ADDENDUM NO. 2

METROPOLITAN SEWERAGE DISTRICT MSD ITT PUMP STATION REPLACEMENT

MSD PROJECT NO.: 2020061
MCKIM & CREED PROJECT NO.: 09596-0001

ADDENDUM ISSUE DATE: JULY 16, 2026

FORCE MAIN PROFILE VIEW
HORIZ. SCALE: 1"=40'
VERT. SCALE: 1"=4'

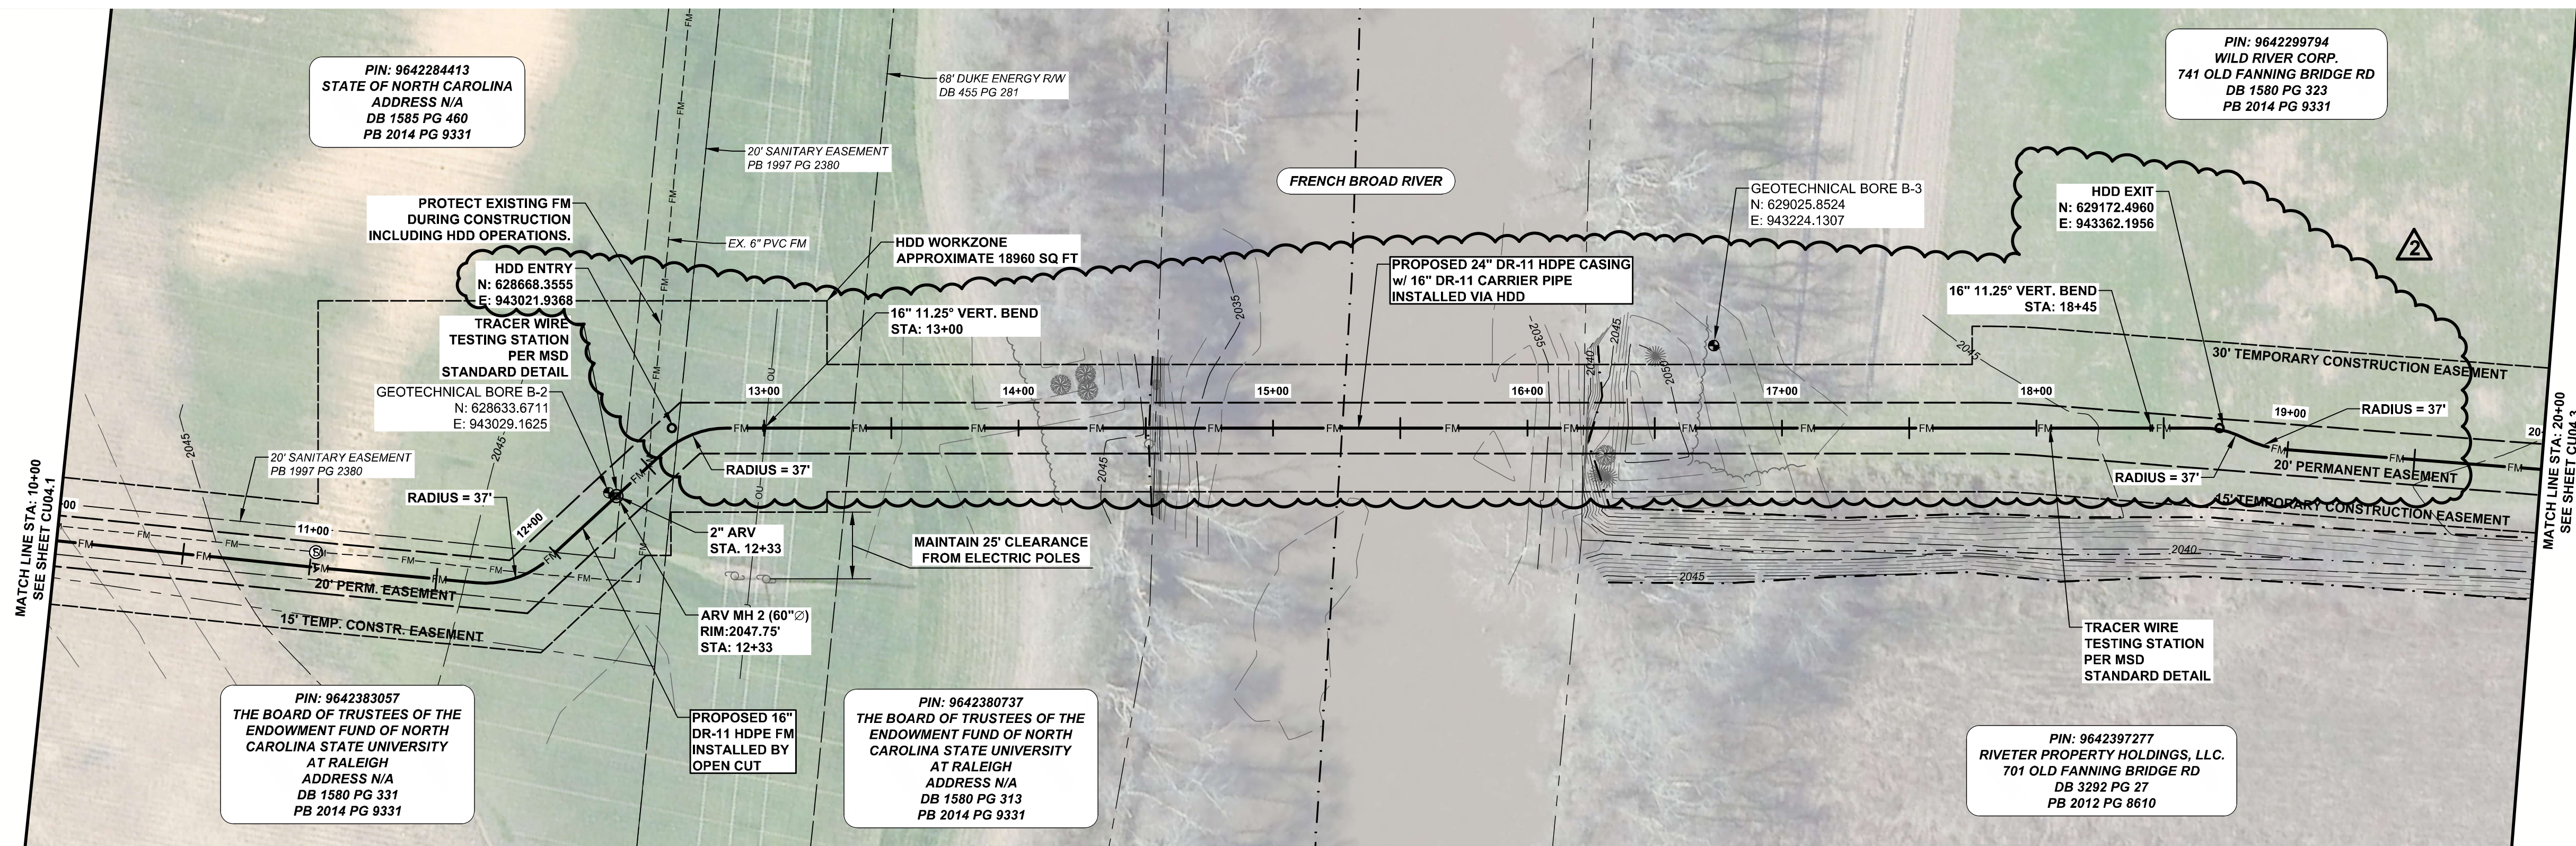
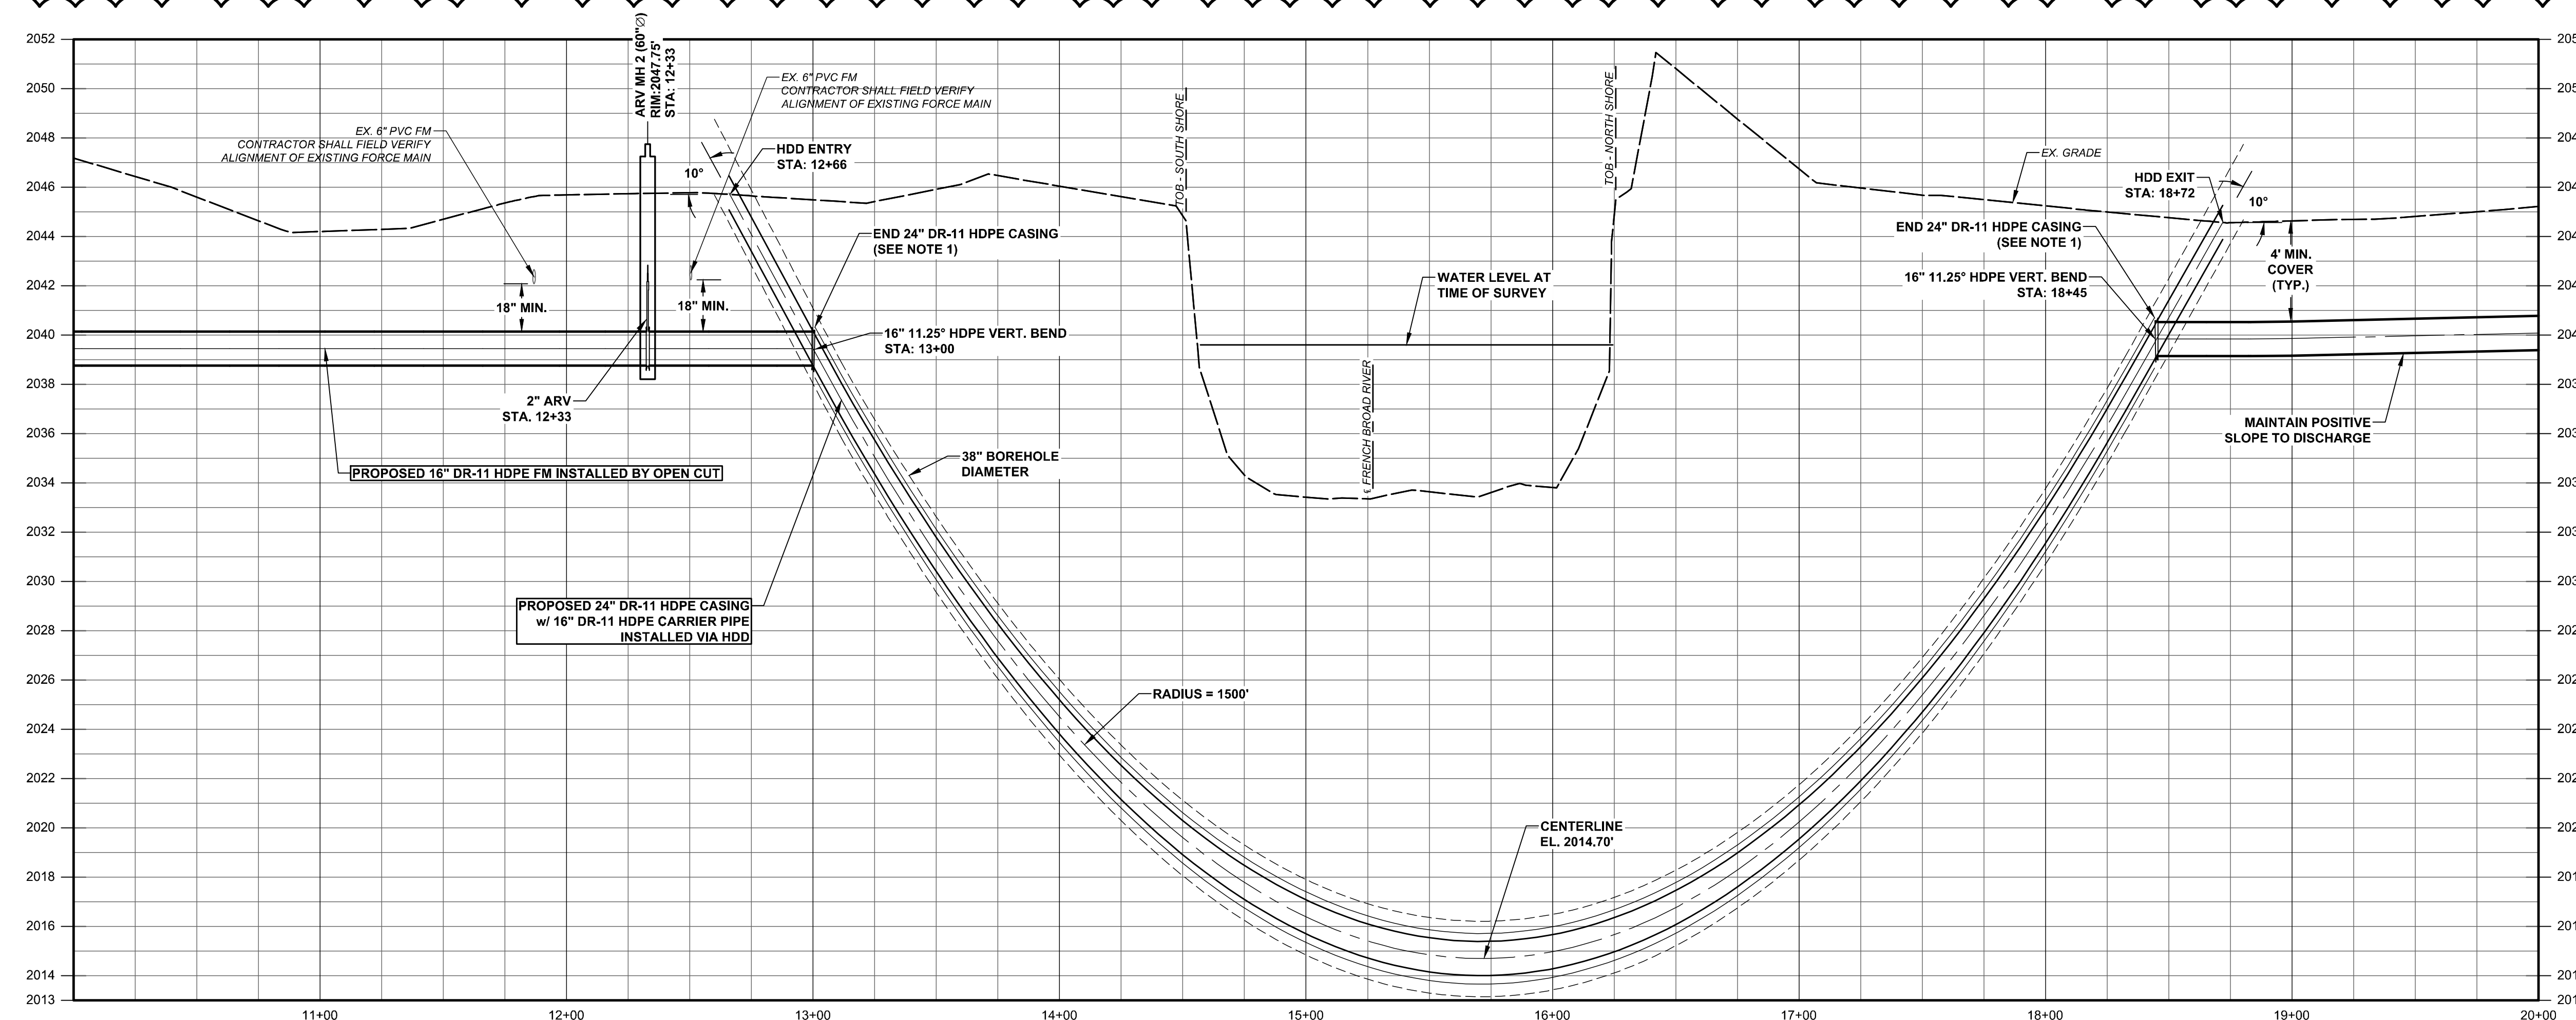
4. **QUESTION: Sheet CU04.1 - Note 6 states that underground electrical lines are shown on the drawing, but such markings are not present.**

25. QUESTION: Confirm the PS Bypass Detail is the same as the FM Bypass callout on the plans.

RESPONSE: CU04.1 shows the underground electrical lines. These electrical lines are also present on sheets CDE05.1, CU05.1, and CS01.1.

RESPONSE: Yes, the PS Bypass Detail on Sheet M01.3 is the same as the FM Bypass callout on CU04.1.

CU04.2
DRAWING NUMBER
2
REVISION

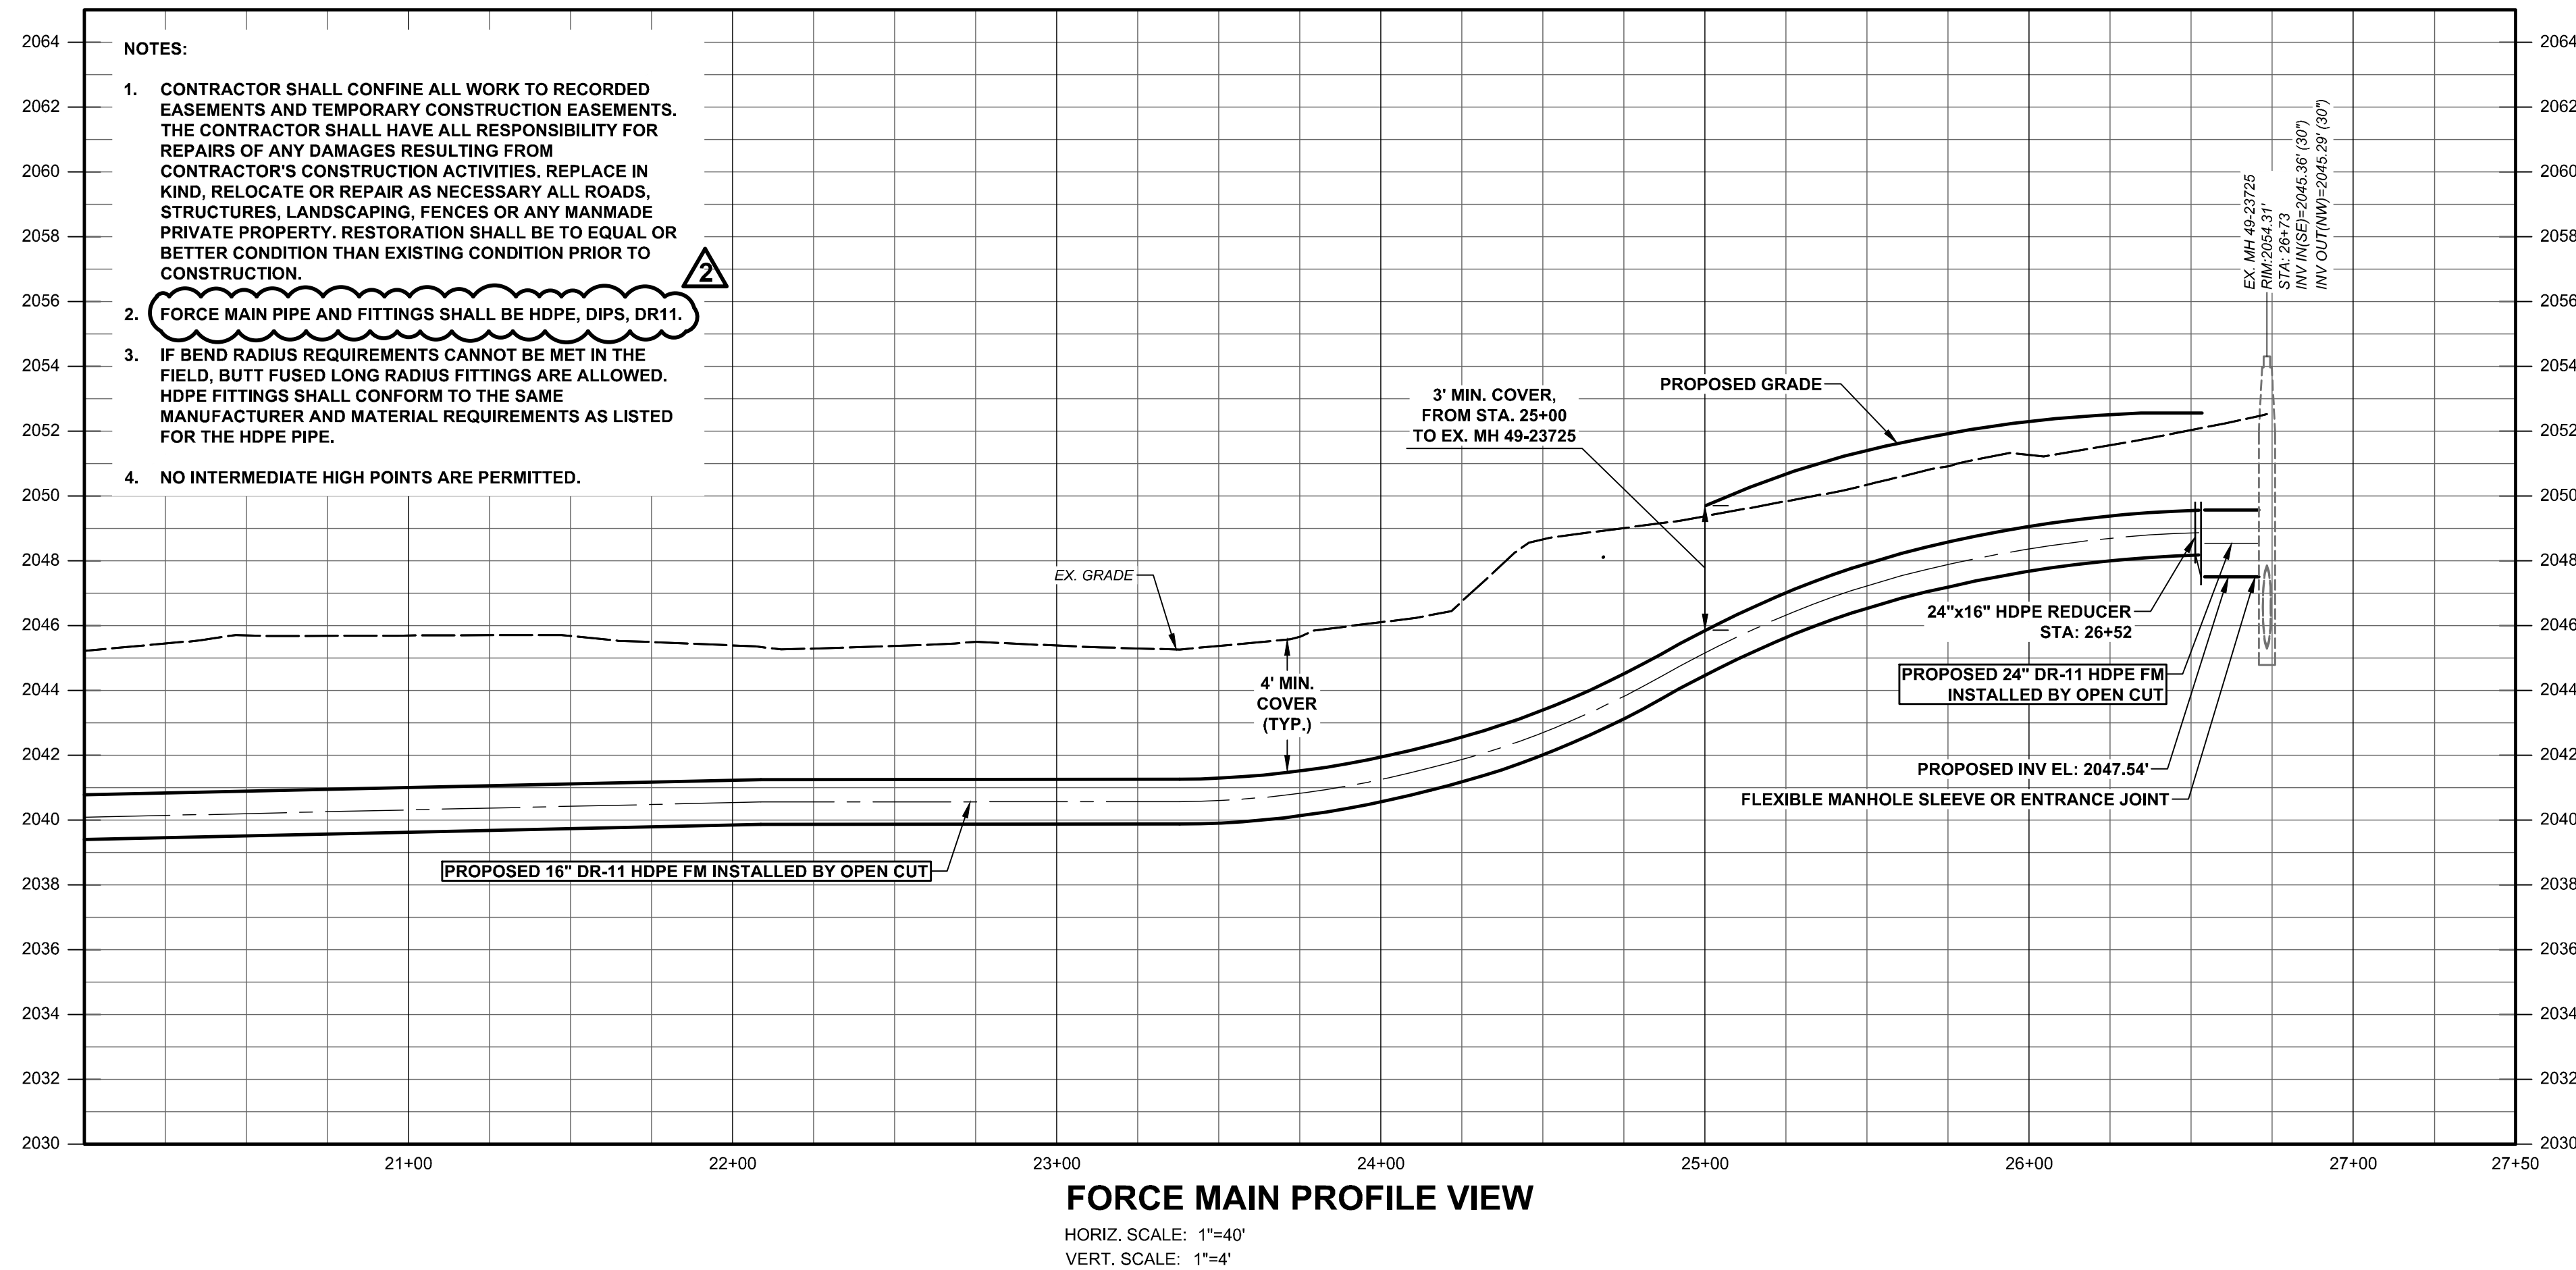
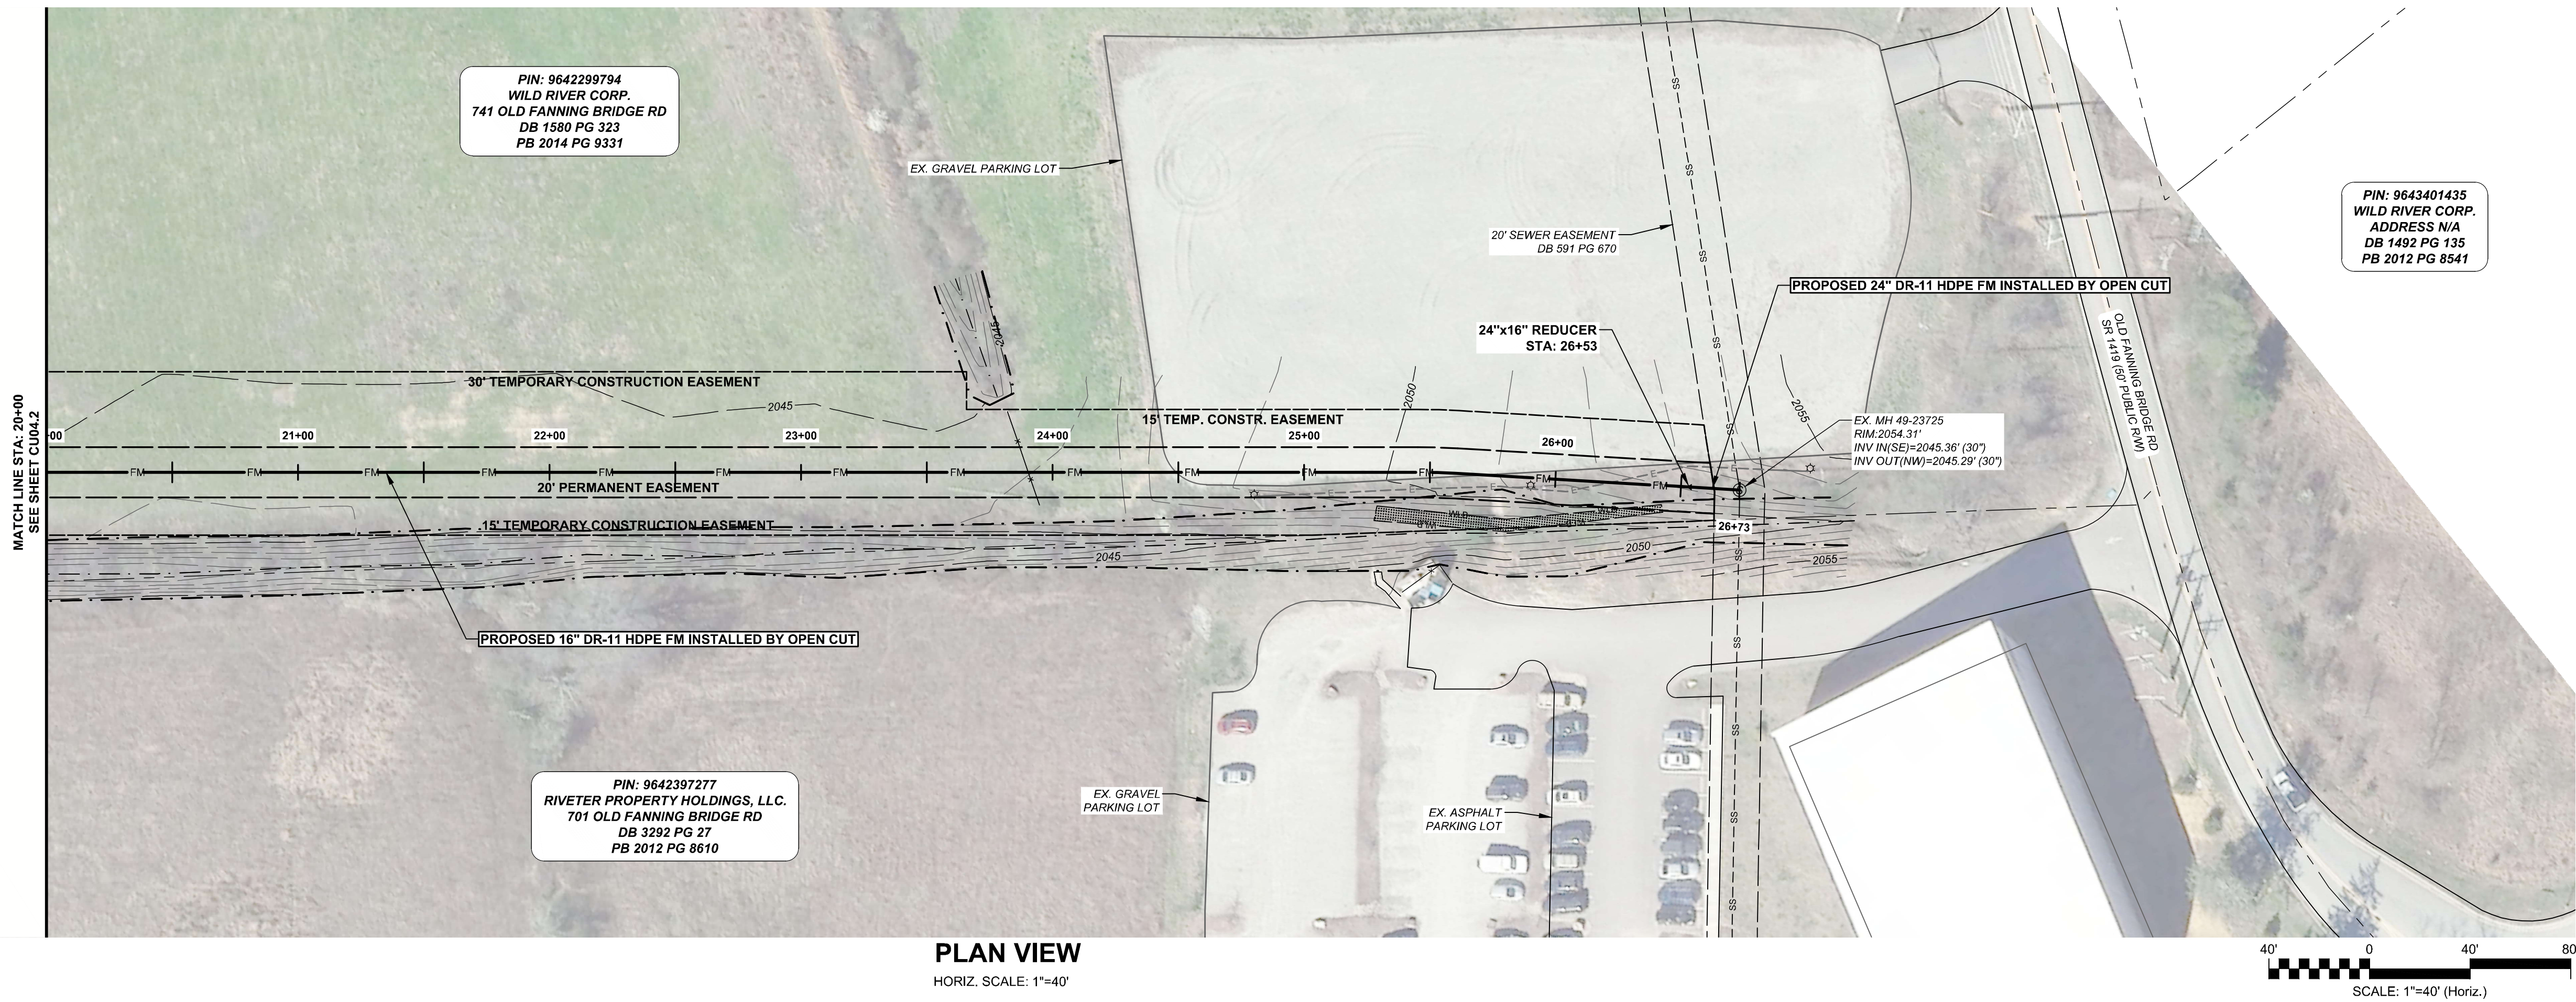
13. QUESTION: After review of the plans with a number of HDD service providers, several have expressed constructability concerns with the proposed 750' radius. Per those providers, given the known rock conditions and the equipment required to ream a 30" to 36" hole, a 750' radius is not feasible. Rather, a radius between 1,500' and 2,500' is recommended by these providers for such a large diameter boring. Furthermore, the dogleg in the easement between Stations 11+75 and 12+75 (Sheet CU04.2) prevents simply adjusting the launch point upstream along the pipe route without the HDD leaving the currently acquired easement. Can you provide additional clarification and/or a revision to the plans that address these constructability concerns? Alternatively, if the design is not changed and an unsuccessful attempt at the current design is performed, will the MSD treat this as a change order and compensate the bidder appropriately?

RESPONSE: The HDD design has been revised. Please see revised sheet CU04.2 attached to this Addendum No. 2. Note, Bidders shall prepare their bids based on the revised HDD alignment and profile shown in the Contract Documents. An unsuccessful HDD installation attempt will not be considered a basis for a Change Order or additional compensation, or an extension of Contract Time.
